MONTGOMERY COUNTY PLANNING DEPARTMENT
THE MARYLAND-NATIONAL CAPITAL PARK AND PLANNING COMMISSION

MCPB
Item No.: 9
Date: 06-15-17

Ridgeview: Preliminary Plan No. 120120010 and Site Plan No. 820120010

Completed: 06/02/17

Figure 4 – Preliminary Plan

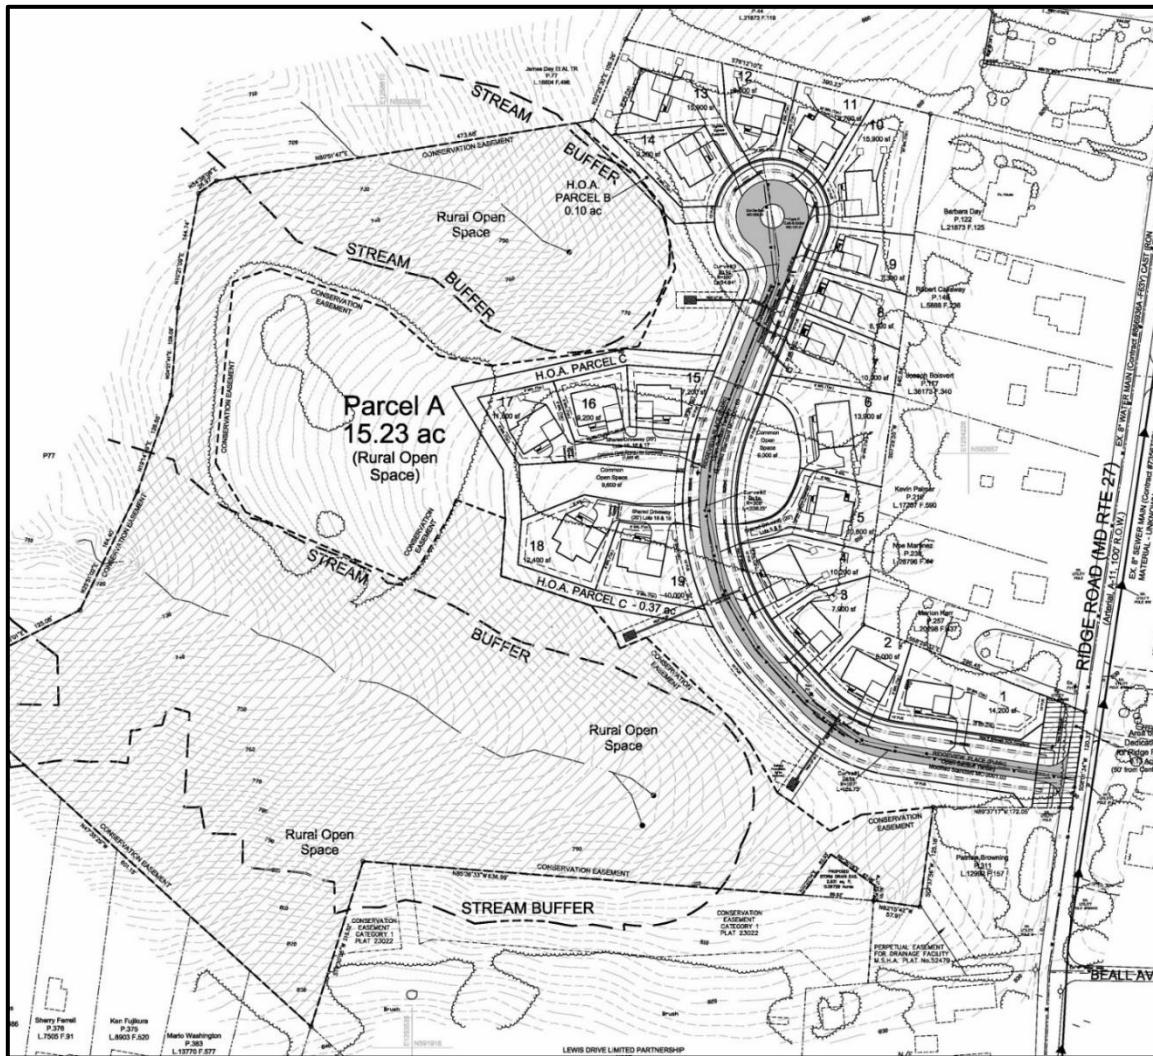
Preliminary Plan, No. 120120010 proposes to subdivide the site into 19 lots for 19 one-family detached dwelling units, and to create a total of 11.58 acres of Category I Conservation Easement and 15.23 acres of Rural Open Space (“Preliminary Plan”). The Preliminary Plan utilizes 10 Transfer of Development Rights (TDRs), consistent with the Damascus Master Plan, to achieve the total density. To access the new lots, a new public tertiary street will be dedicated and constructed for public maintenance and use. The street provides access to Ridge Road and is designed to avoid impacts to the on-site stream valleys. The Preliminary Plan also creates open space parcels near the middle of the site to provide common open space for the future residents. The proposed lots are clustered, allowing for the creation of the 15.23 acres of rural open space, which includes the 11.58 acres of Category I Conservation Easement protecting the on-site stream valley buffers and areas of existing upland forest, and an additional 3.65 acres of unforested rural open space. The Preliminary Plan is being reviewed under the Chapter 50 regulations in effect before February 13, 2017 because the Preliminary Plan was accepted prior to the February 13, 2017 effective date of the new regulations.

- *Minimize impervious surfaces through environmentally sensitive site design techniques...*
The Preliminary Plan is minimizing impervious surfaces through the use of small lots and by clustering them on the eastern portion of the property, where it is closest to Ridge Road, which minimizes the length of the access road and private driveways. In addition, the Preliminary Plan is requesting a design modification from MCDOT for the new street to allow sidewalks only on one side of the street, where the majority of the lots are proposed.

The Preliminary Plan shows a sidewalk as part of the frontage of Ridge Road. Off-site connections of that sidewalk are not possible at this time because of limited existing off-site right-of-way. The design of the site does not prohibit future natural surface trails from extending off-site into adjacent park or developed lands.

The new public street providing access to the proposed lots is planned as an open-section tertiary street, following MC-2001.03 but modified to only provide sidewalks on one side of the street. The new street will be in a new 67-foot wide right-of-way and include a 20-foot wide roadway, increased width side ditches and a five-foot wide sidewalk on one side of the street.

- 10) The Applicant must dedicate a 67-foot wide right-of-way, for cross-section MC-2001.03 open-section tertiary, as modified by MCDOT, for the road designated as Ridgeview Place on the Preliminary Plan.

- 11) The Applicant must construct all road improvements within the rights-of-way shown on the approved Preliminary Plan to the full width mandated by the design standards imposed by all applicable road codes as modified. Only those roads (or portions thereof) expressly designated on the Preliminary Plan, “To Be Constructed By _____” are excluded from this condition.

- 13) The Applicant must coordinate with MDSHA to construct a five-foot wide sidewalk along the Subject Property frontage of Ridge Road, as shown on the Preliminary Plan.

Figure 8 – Rural and Common Open Spaces

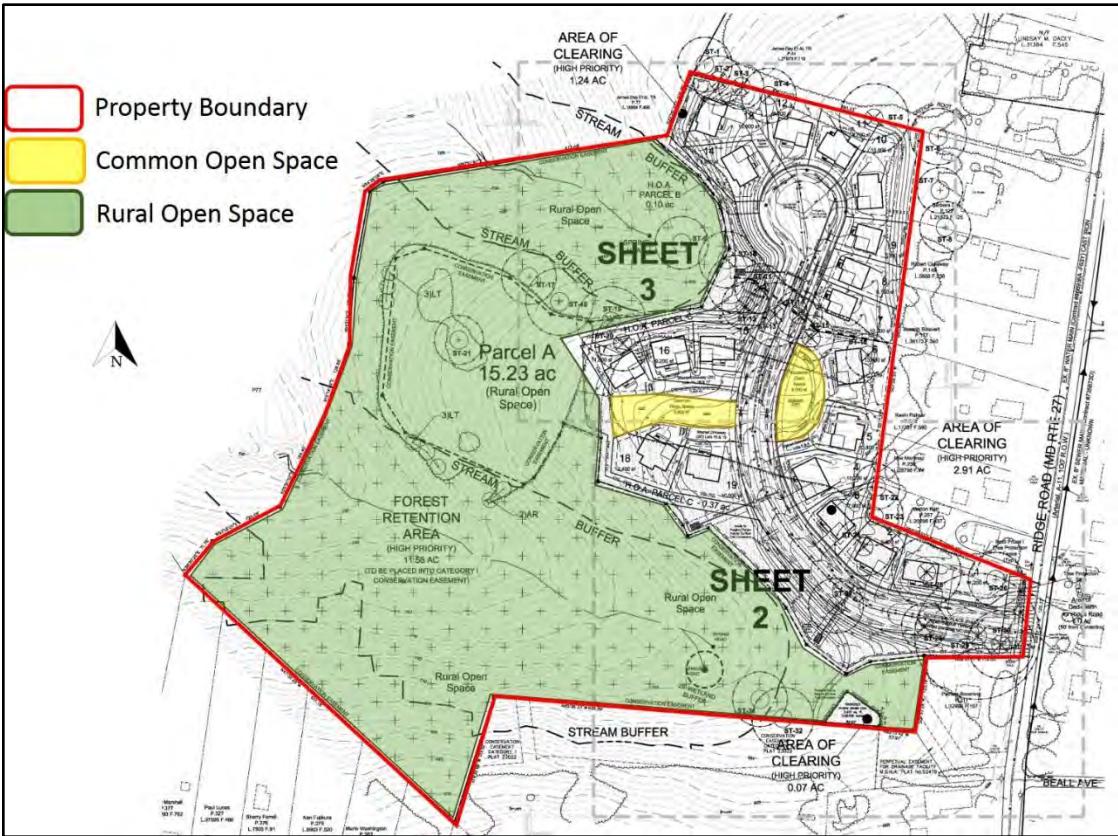
A major tenant of the RNC zone is the provision of rural open space. Developments must provide a minimum of 65% rural open space, and this space should be contiguous and must meet the goals of the applicable Master Plan. Rural open space may be managed and maintained through various non-structural means including meadow or woodland management and agriculture or left passive. Finally, the land must be placed in a restrictive easement identifying the open space area. This Application is providing a total of 69% rural open space (15.23 acres out of 22.6 acres), in a contiguous HOA parcel that is located in the western 2/3 of the site (figure 8), which was identified in the Master Plan as a priority for Legacy Open Space and must be left as open space as a condition of the water and sewer category change affecting the property. The Applicant proposes a Category I Conservation Easement over all forested areas within the rural open space, with the existing unforested portions to remain as meadow or be allowed to naturally regenerate, dependent on the desires of the future community residents.

Based on Section 59-C-9.574(e), development applications with 10 or more dwelling units must provide an unspecified amount of land as common open space that is intended to be used for the enjoyment of future residents, must be located in a central location, and must not count towards the requirements of the rural open space. This Application proposes two areas of common open space; an approximately 9,000 sq. ft. Community Green that includes a seating wall, a paver path and landscaping, and a 9,600 square foot Lawn that provides a maintained view and entry from the developed portion of the property into the rural open space areas (figure 9). Both are located in the center of the developed portion of the site, and are connected to each other and to the greater development by sidewalks.

The location of the open spaces is safe, adequate and efficient. The Site Plan includes two types of open space; common open space and rural open space. The rural open space is a requirement of the RNC zone, needing to comprise at least 65% of a site, and should be located in a contiguous space protecting natural and scenic resources. The rural open space on the site is approximately 69% of the total tract, and protects a large amount of existing forest and stream valley buffer areas on the site. Future residents will have passive access to the rural open space from multiple locations along the public road and through the common open space area. The common open space is required for RNC zoned developments with more than 10 dwelling units and should be located in a centralized location. The Site Plan includes two separate but adjacent areas of common open space. One is a more formal 9,000 square foot community green that has an open central area, with decorative trees, a path and seating located around the exterior. The second common open space is a 9,600 square foot lawn which co-serves as a visual and physical connection to the rural open space. Both spaces are readily accessible to all of the lots and have high visibility from the road and from the proposed dwellings.

- 3. Rural Open Space, Facilities, and Amenities
 - a. The Applicant must provide a minimum of 15.23 acres of Rural Open Space (69% of net tract area) on-site.
 - b. Before the final inspection for the residential dwellings on lots 5 or 6, all public amenities within the common open space community green area on the east side of the public road, as shown on the Certified Site Plan must be completed.
 - c. Before the final inspection for the 15th residential dwelling unit, all landscaping and amenities in the common open space area on the west side of the public road, as shown on the Certified Site Plan must be established.
- 4. Maintenance of Public Amenities

WSSCCR 14-DAM-01A (Kings Valley Ltd. Part.): Water Service Area Categories Map

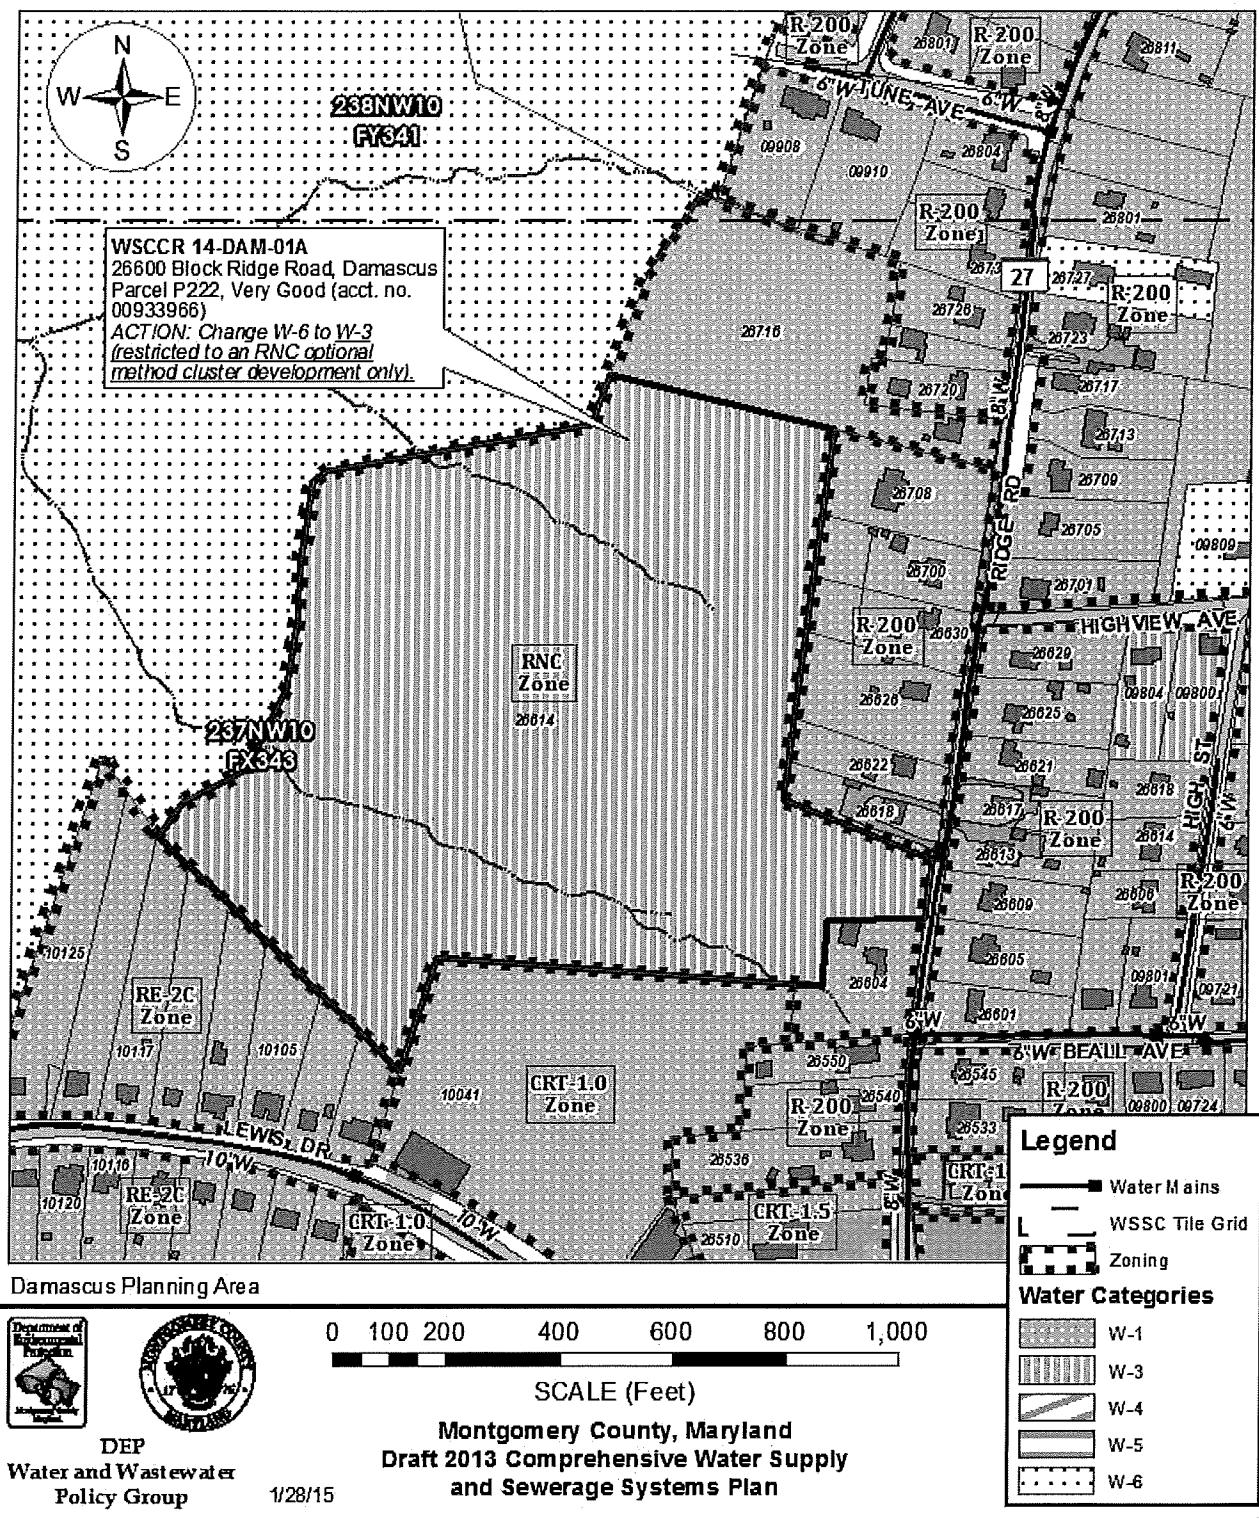
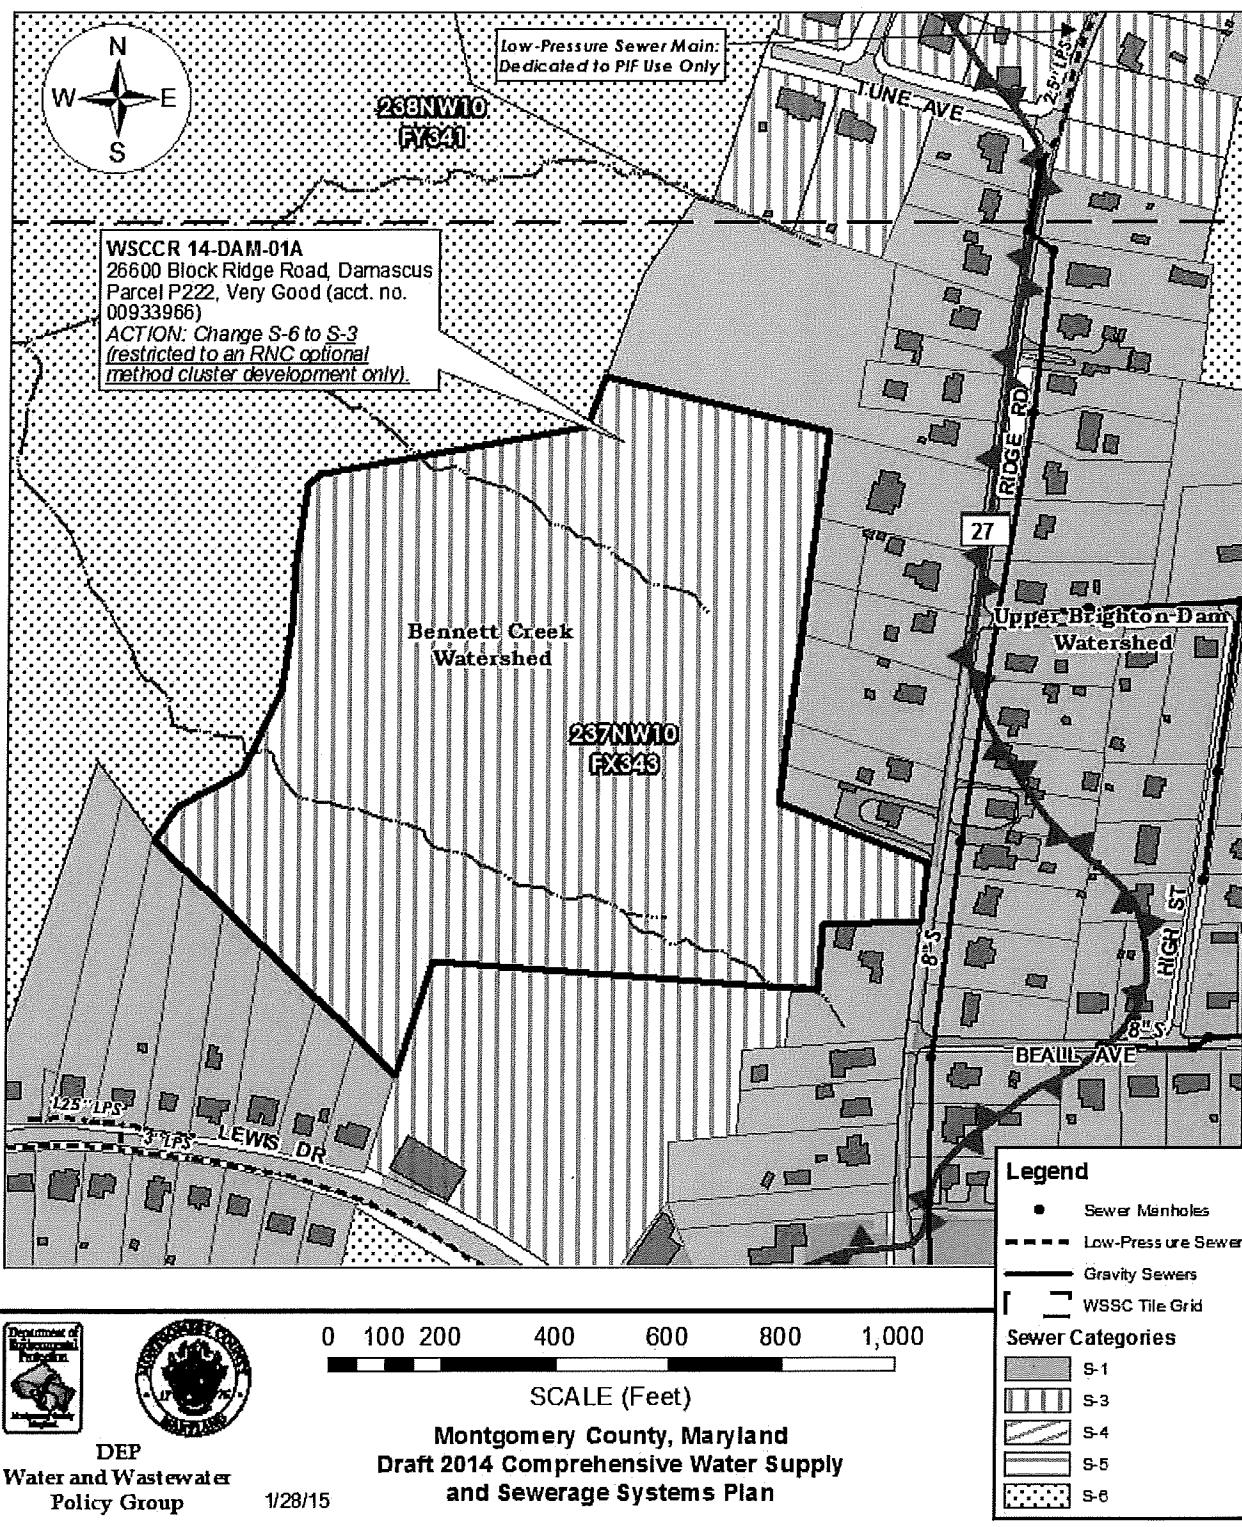
- WSCCR 14-DAM-01A (Kings Valley Ltd. Part.): The M-NCPPC staff report commented that approval for W-3 and S-3 should apply only to the area of the site shown in the planned sewer service envelope in the Damascus Master Plan. DEP staff explained that the designation of the entire site as W-3 and S-3 is only an interim measure. Residential lots on the site are expected to stay within the planned sewer envelope. When available for DEP's mapping service area category tools, these lots will retain W-3 and S-3, while undeveloped, open space parts of the subdivision will revert to W-6 and S-6. The end result will follow the master plan's recommendations.
